Discontinuation Notice of Round Connectors Model Y92E-S__PVC series.

Product Discontinuation

Recommended Replacement

[Body color]

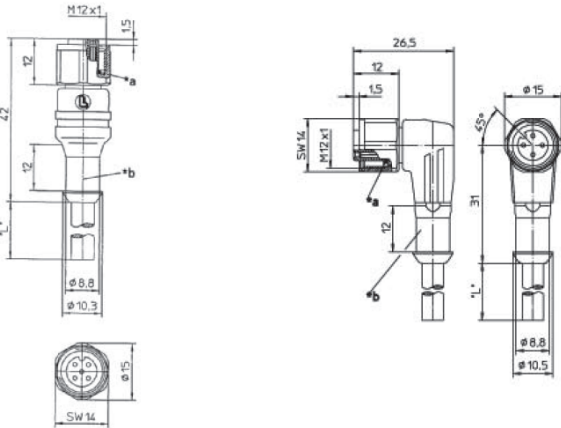
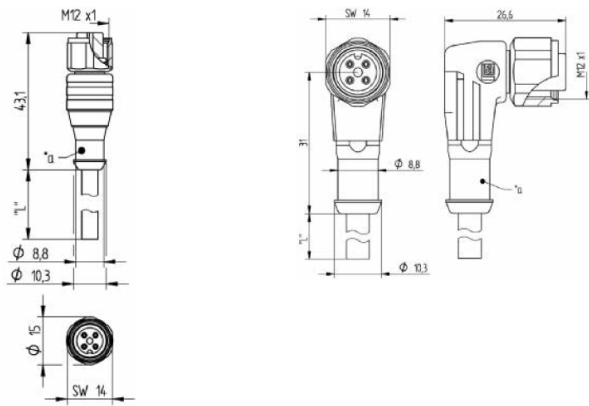
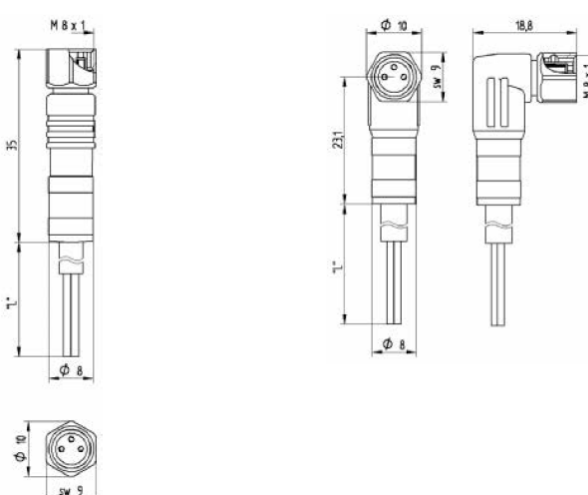
Product discontinuation Model Y92E-S__PVC series	Recommendable replacement Model Y92E-S__PP series
M12 models 	M12 models 
M8 models 	M8 models
